## ADDENDUM NO. 2

OWNER: Town of Tignall

PROJECT: Wastewater Treatment Plant Improvements

**ENLARGED ELECTRICAL PLANS**

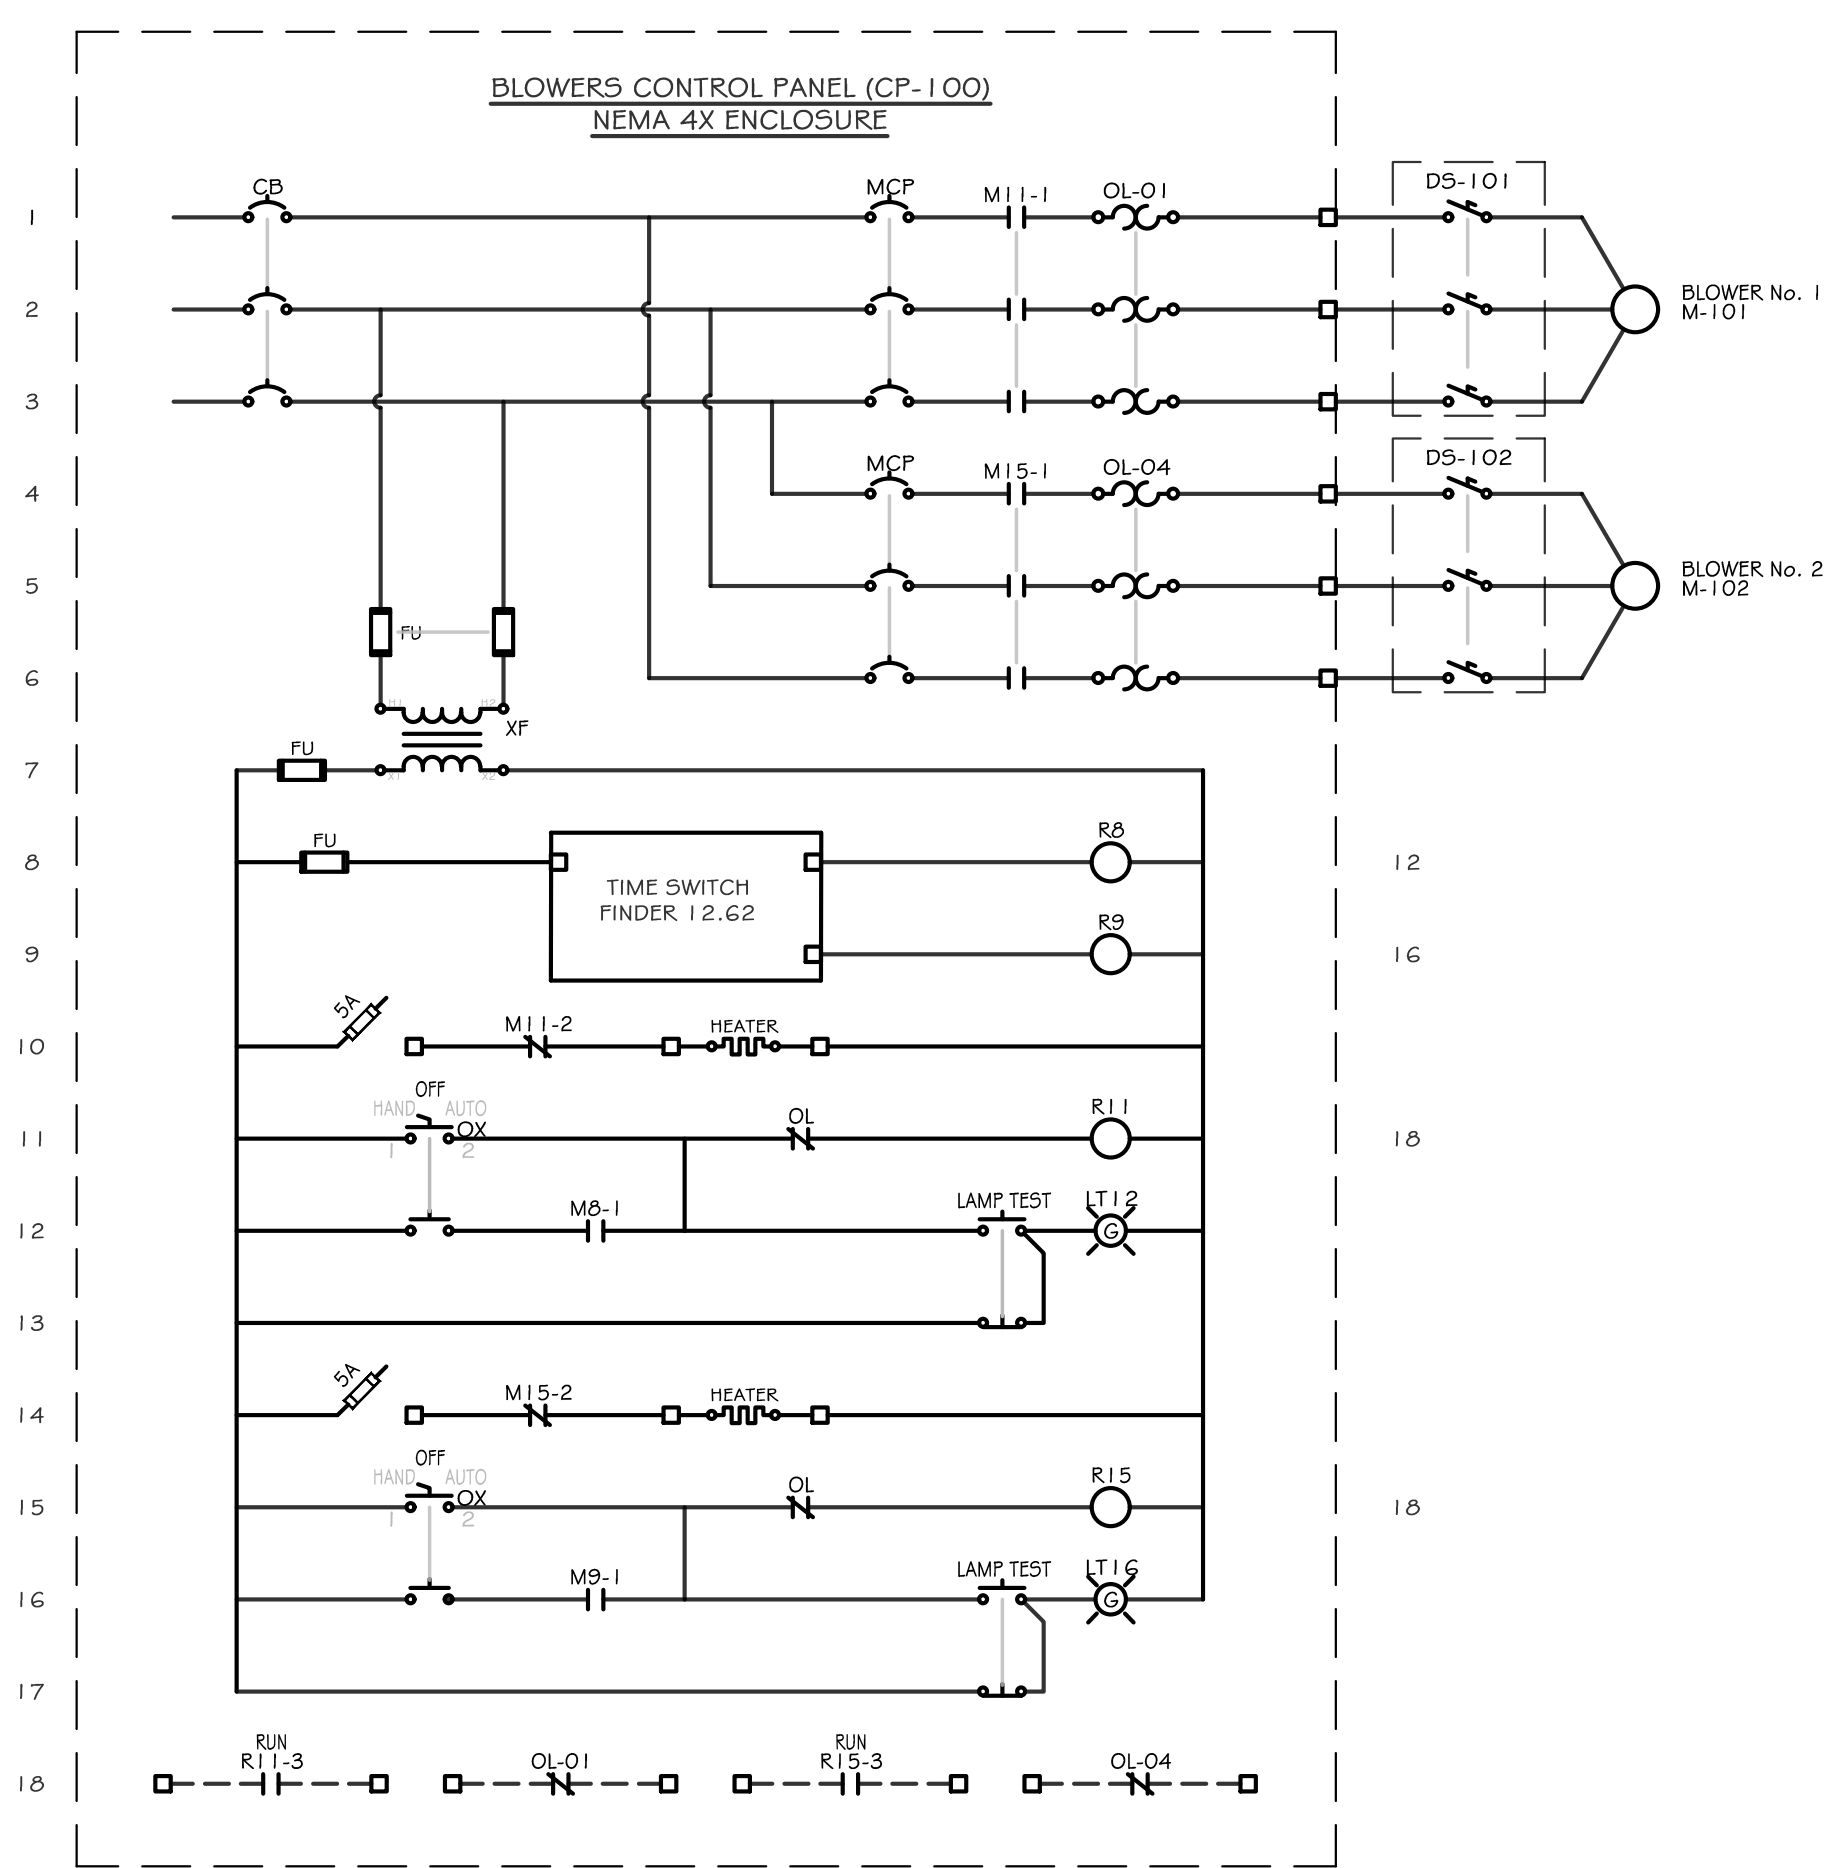
- Answer:** Electrical ductbanks installed under roadways shall be concrete-encased. Ductbanks in all other areas shall be sand filled.
53. **Question:** Will the TFR-C on E.3 be 3R since this is shown outside on E.6?

- Answer:** Transformer TFR-C shall be NERA 3R.
54. **Question:** Please confirm requirements for the "List of Project References" section in the QuestCDN bid submission.

**BLOWERS CONTROL PANEL SCHEMATIC**  
SCALE: N.T.S.

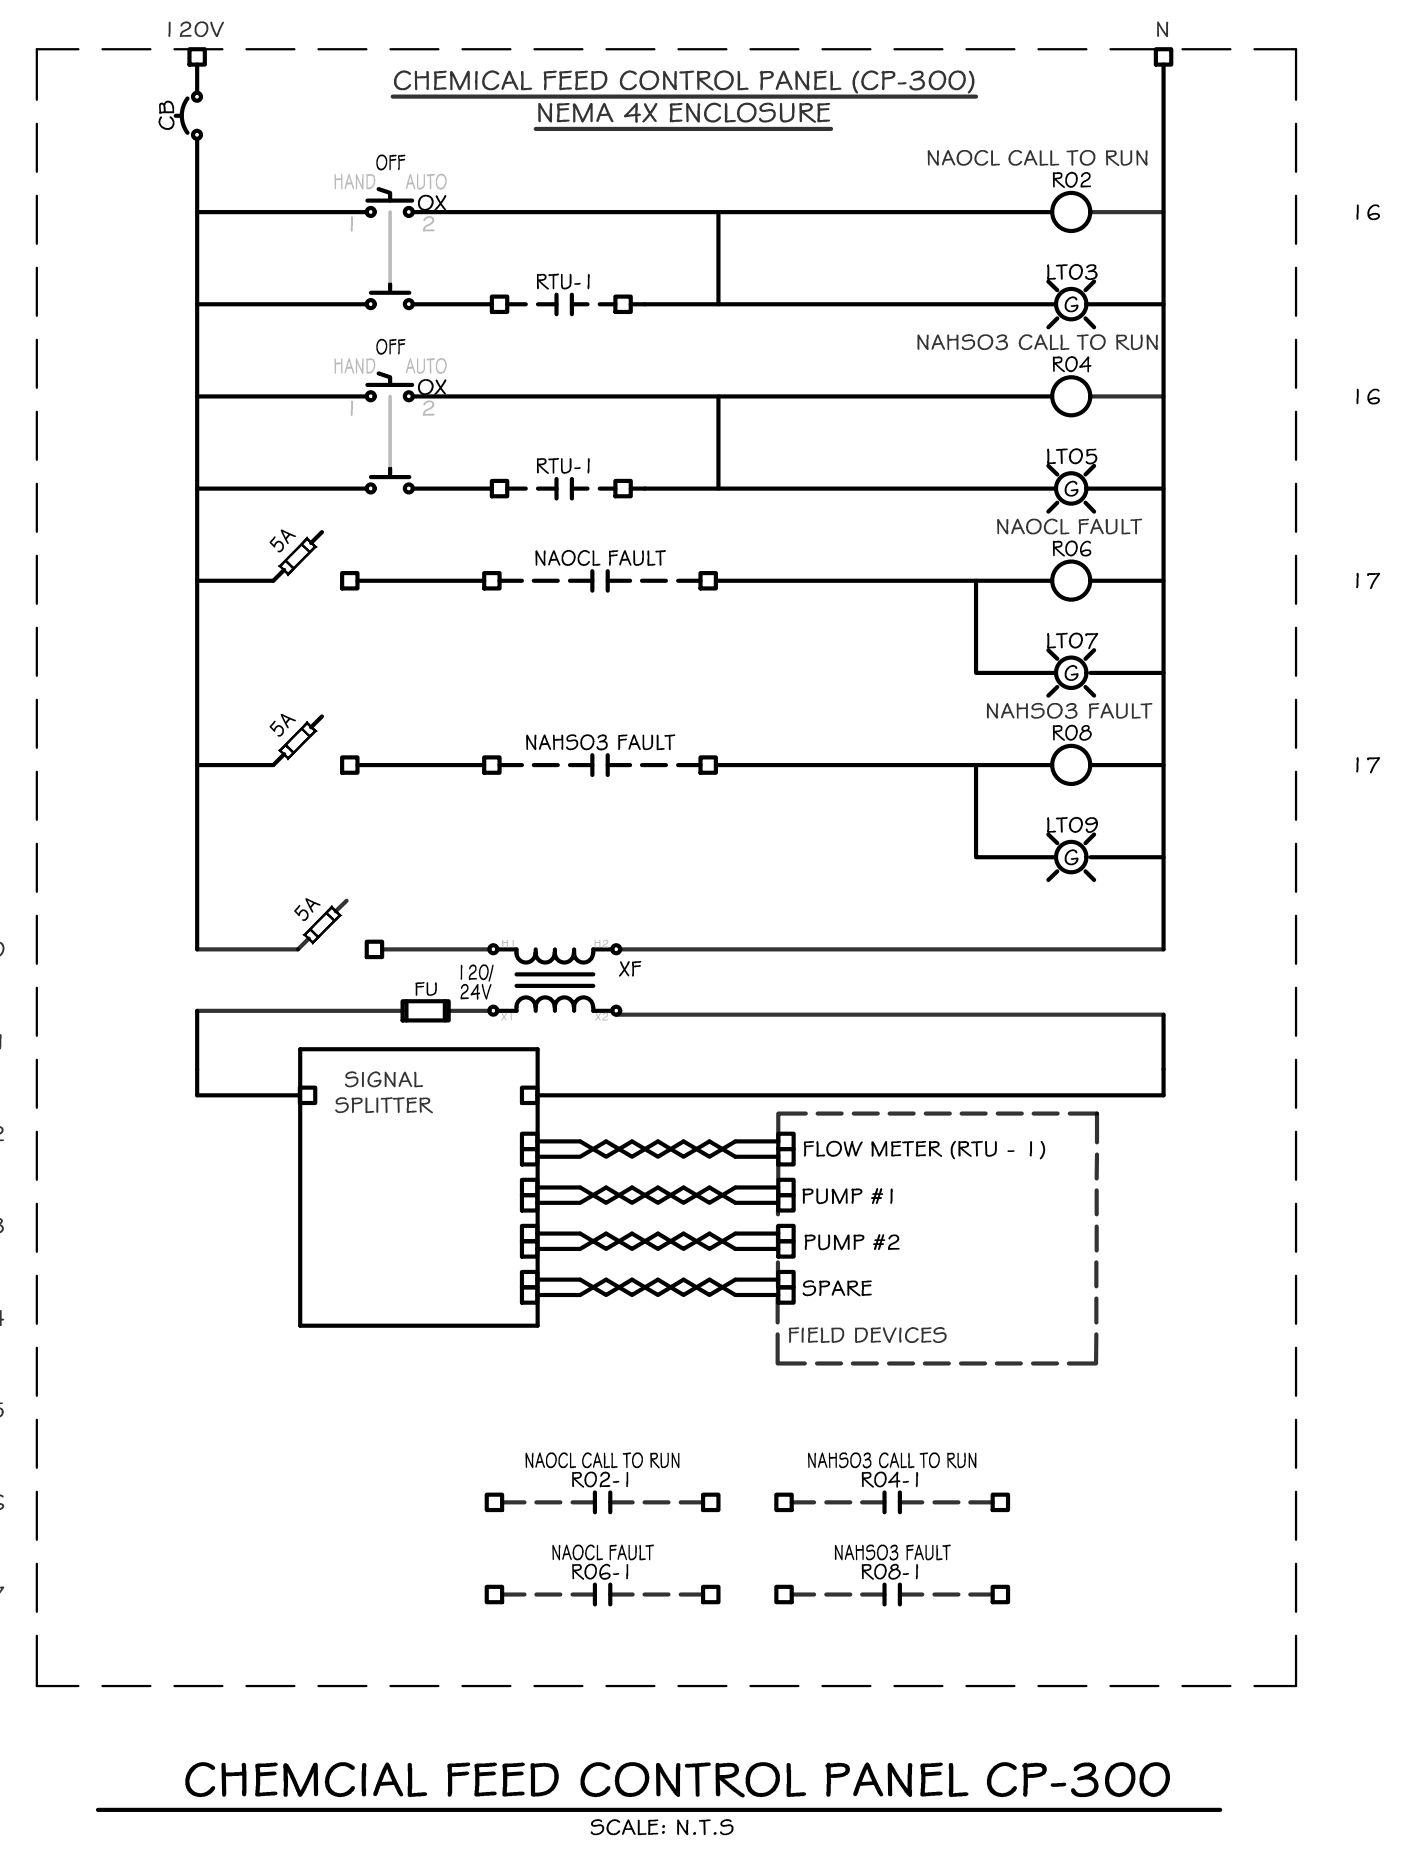
50. **Question:** Sheet E.7 indicates that Blower Control Panel CP-100 shall be provided by Applied Industrial Controls or Dublin Automation, and that the Chemical Feed Control Panel shall be provided by Applied Industrial Controls. Note 2 further indicates that CP-100 and CP-300 may be combined into a single control panel. Please confirm the intended supplier(s) for each control panel, the required installation location if the panels are combined, and provide applicable specifications.

- Answer:** Both control panels (CP-100 and CP-300) may be provided by either Applied Industrial Controls or Dublin Automation, or an Engineer approved equal. Disregard Note 2. CP-100 and CP-300 are intended to be provided as separate panels and are not to be combined. Installation locations shall remain as shown on the contract drawings for each respective panel. Applicable specifications are as outlined in the project documents for control panels.
